5. Zoning Case 19-10; LHB/Essentia Health, Site Plan

**ITEM DESCRIPTION: ZONING CASE 19-10: SITE PLAN LHB/ESSENTIA
CLINIC AT 1413 HIGHWAY 33 SOUTH**

MEMO

SUBJECT: Essentia Health Clinic– 1st Review

DRAWING TITLE:
LANDSCAPE PLAN

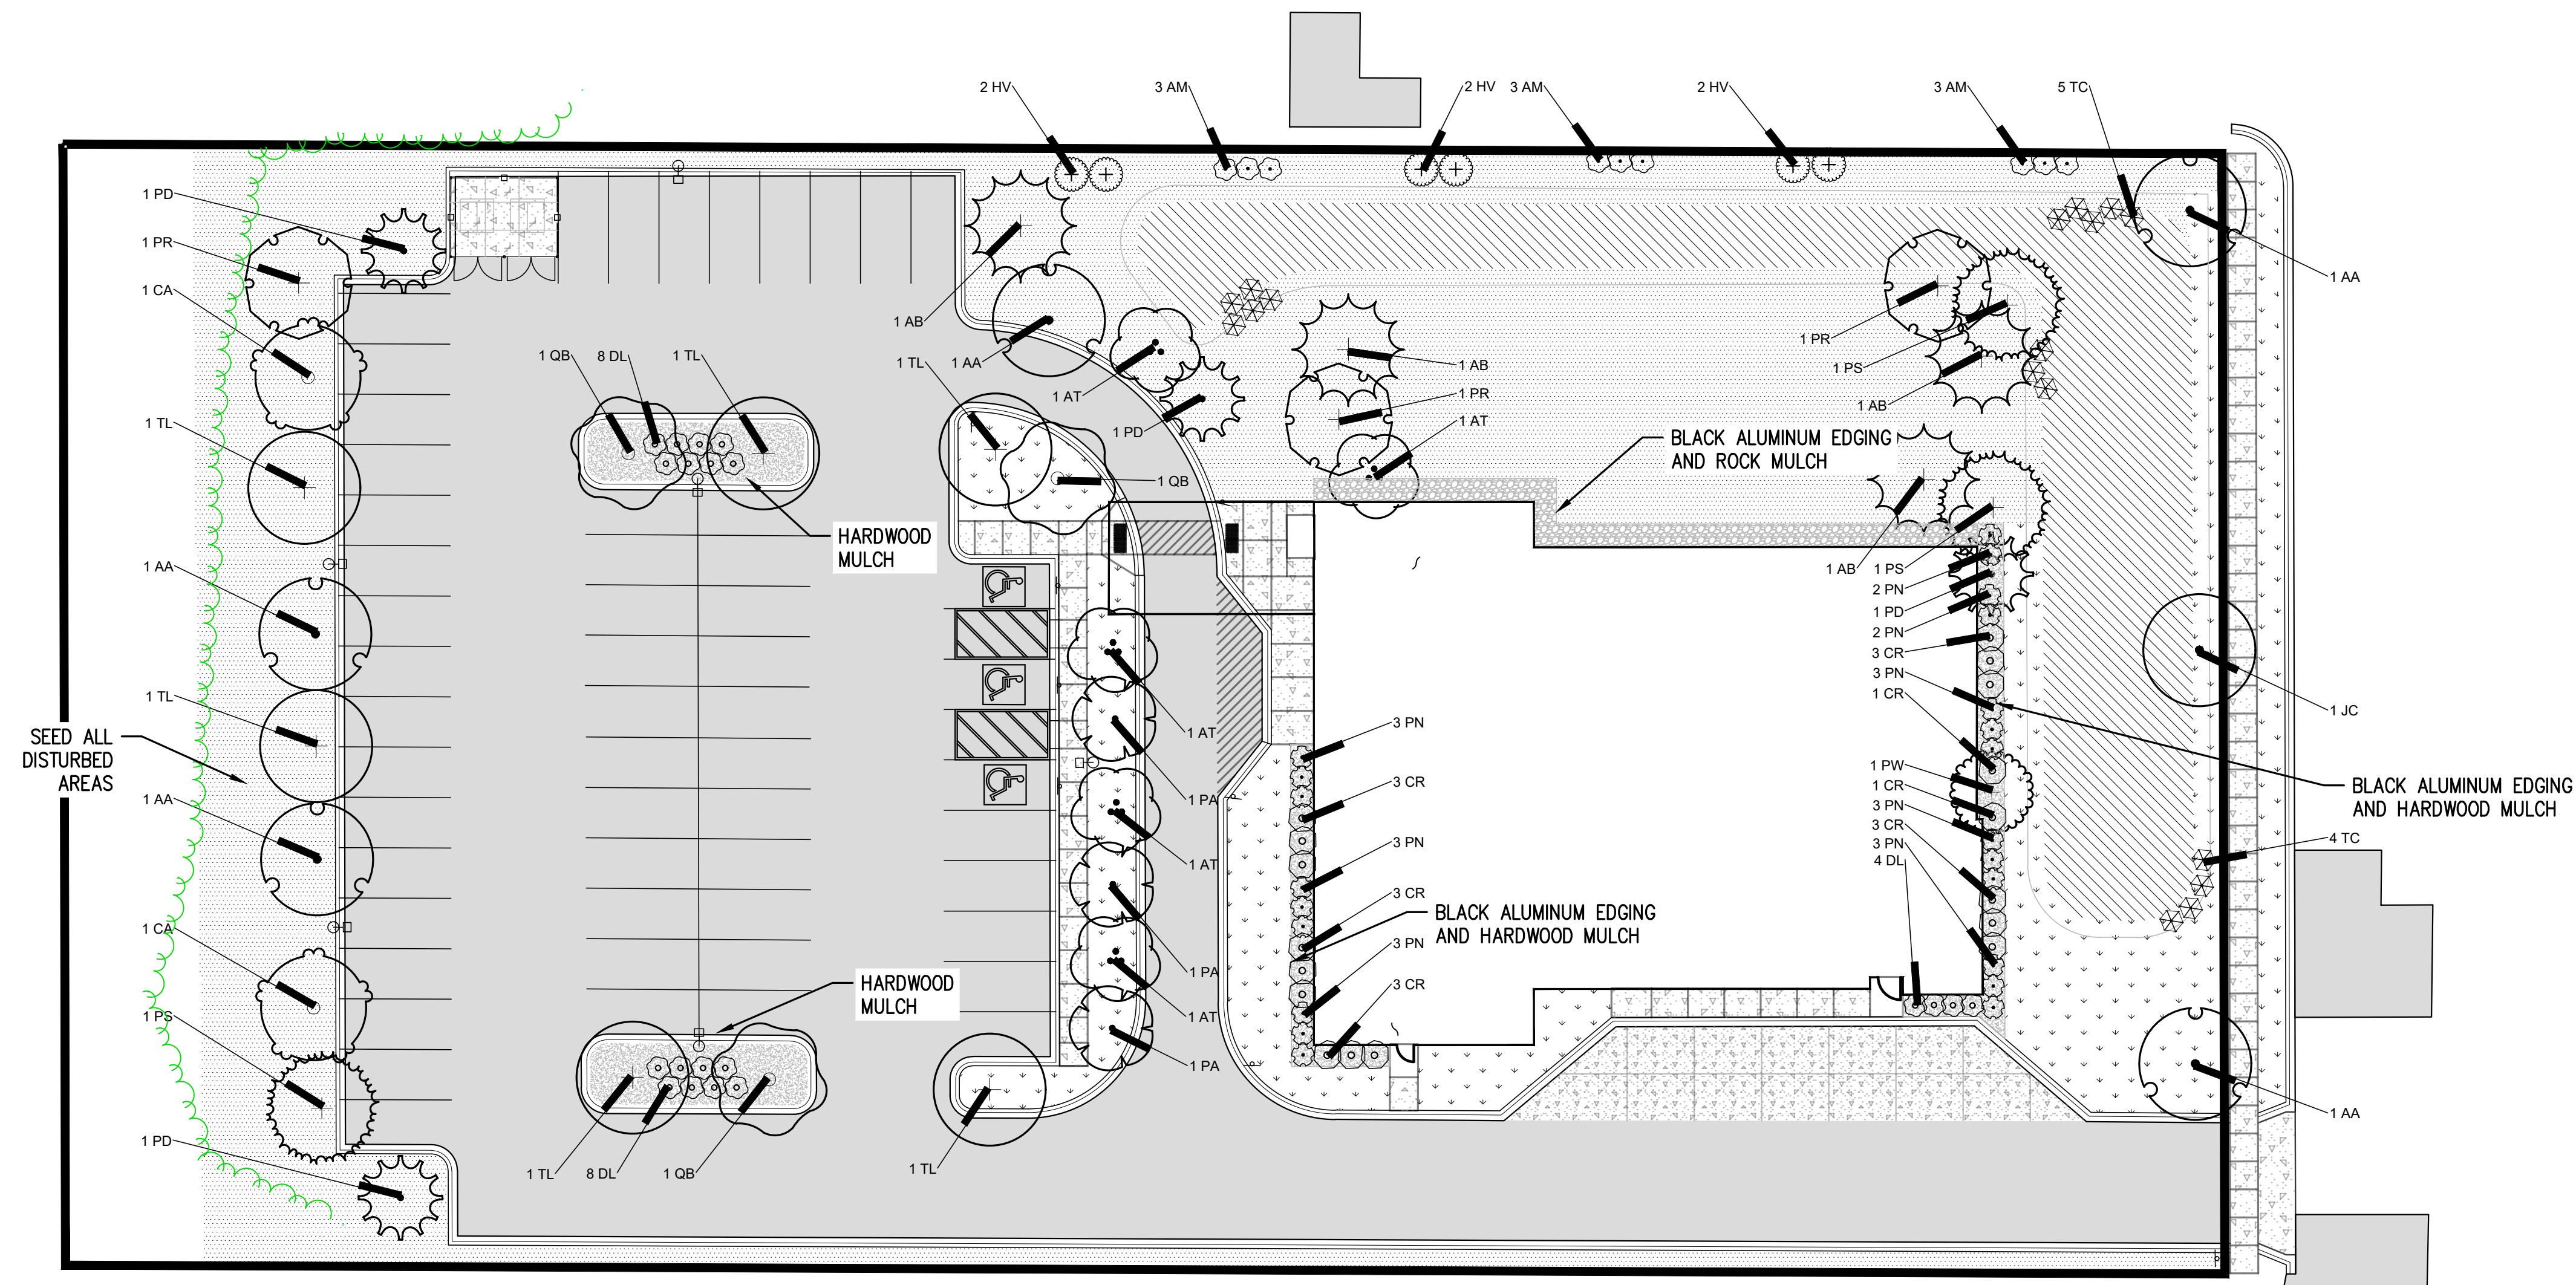
The landscape plan shows 31 overstory plantings plus understory trees and shrubs, the site is required to have 24 overstory plantings in addition to understory trees and shrubs.
